Platform A1 - Booth area  
Previous comments are  
still valid, see following  
slides

Platform A1 – Oven area

Platform A2 – Elevators area (axes 10-12/013-014):

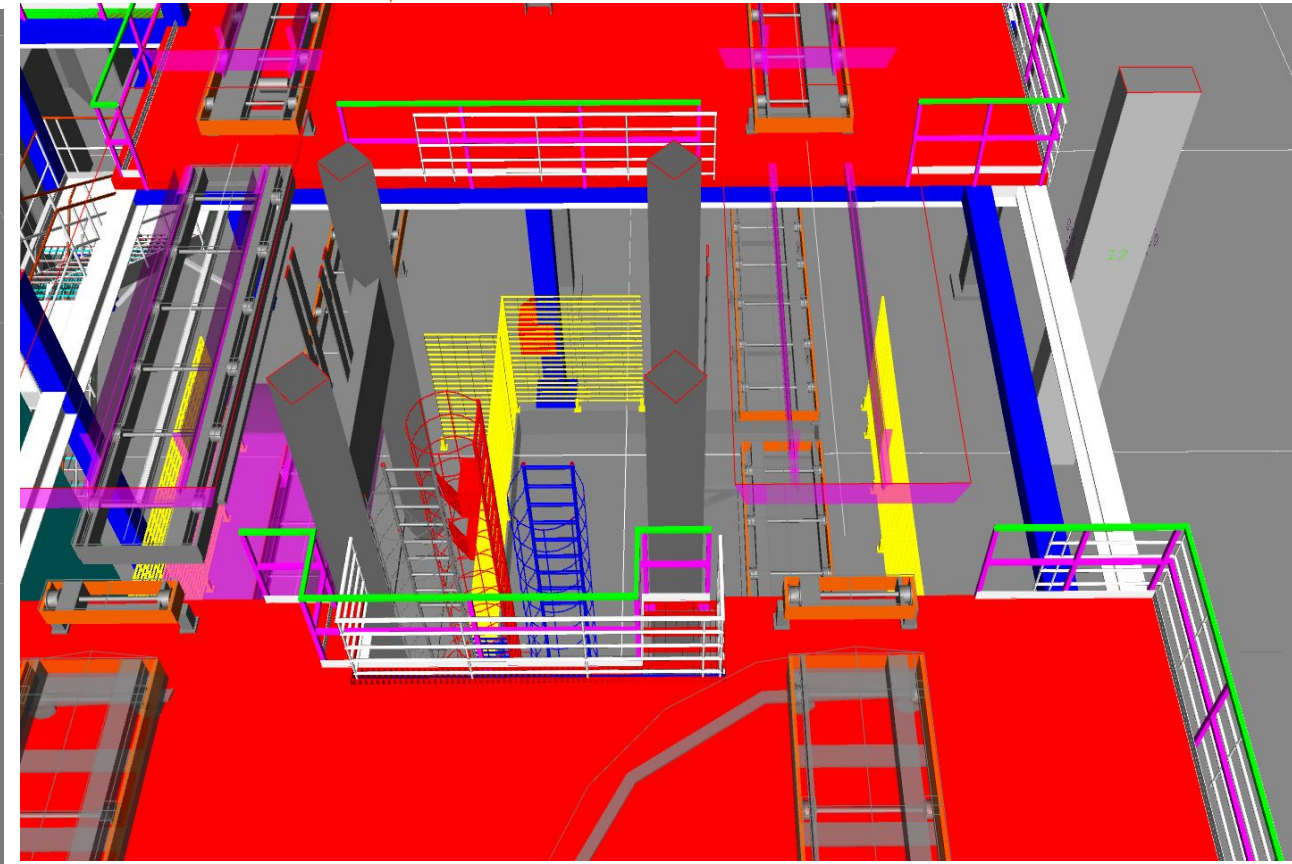
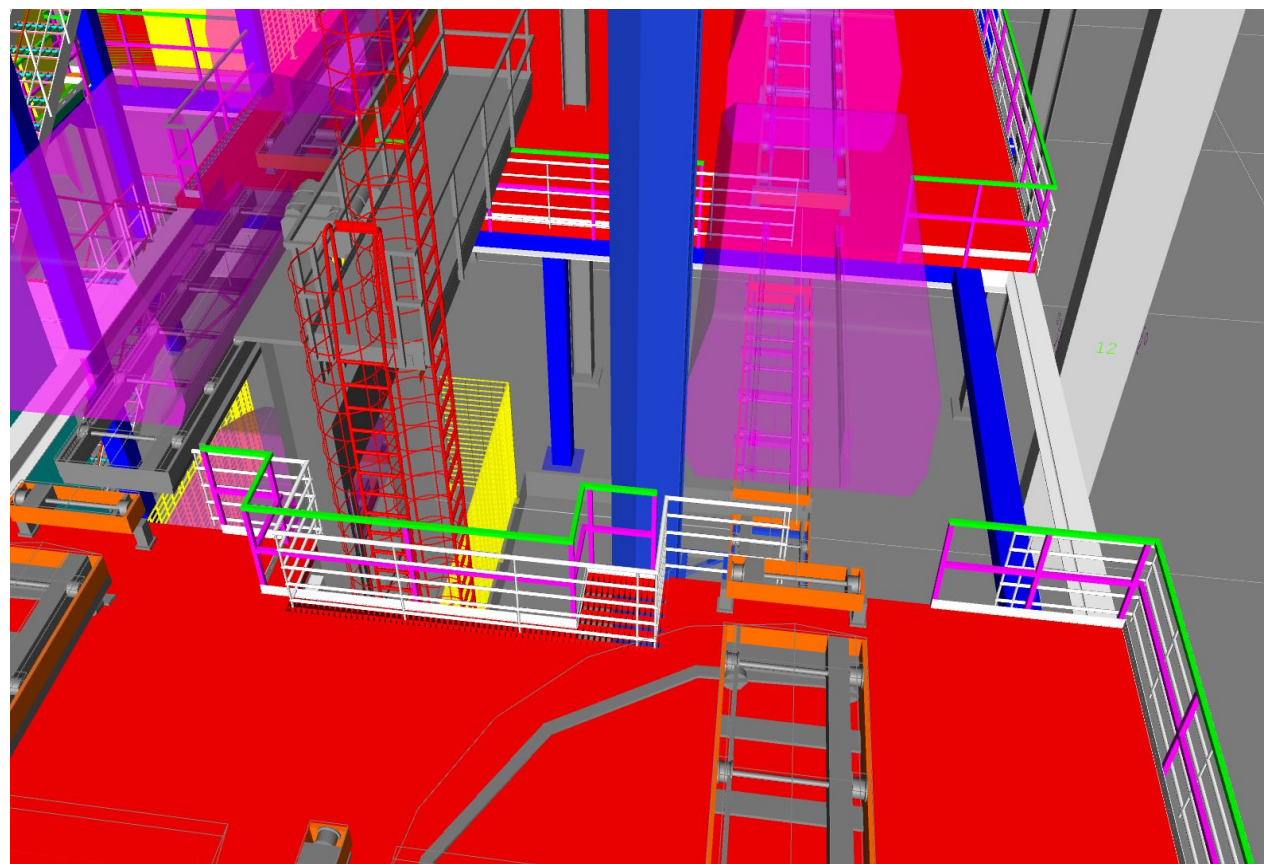
Update:  
Still not correct, use General  
layout to see handrails and  
platform configuration!

Platform A2: finally we need to discuss about longitudinal support for Conveyor  
Roller-beds, turning tables and transfer-tables  
I will send this information after I have discussed with my colleague from Conveyor dpt  
Axes 10-12/014-020

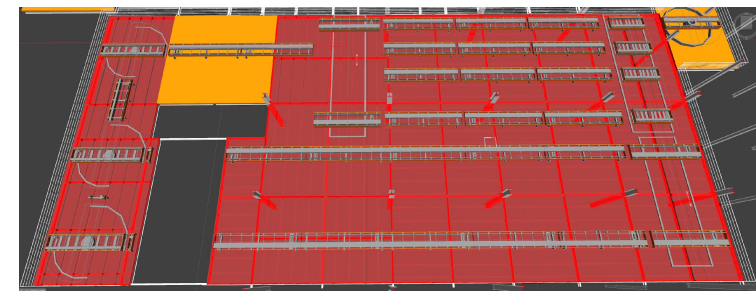
As I told you last time I need to give you precise info of where to support the conveyor tables (roller-beds, transfer table, turning table)  
In the meantime consider the ones in these pictures (for conveyor center-lines use the Gen. Layout)
